Warranty Bulletin

95-18

Date: **May 1995**
Section: **6**
Subject: **DIODE INSTALLATION IN BATTERY COMPARTMENT**
Application:

FIGURE 1

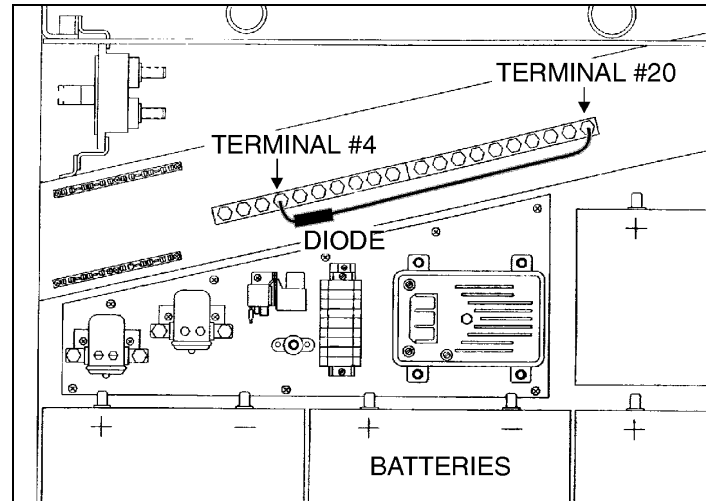
In order to eliminate the possible interference in the P.A. system, occurring when central heating system's valve discharges itself, the Prévost Car engineering department have recently made a modification that you can perform on your own vehicle. Perform this modification according to the following procedure.

1. In last baggage compartment, open battery compartment.
2. Unscrew nuts from #4 and #20 terminals (Fig. 1), install diode assembly between these two terminals and reinstall nuts.

Caution: Wire extremity with diode should be installed on terminal #4.
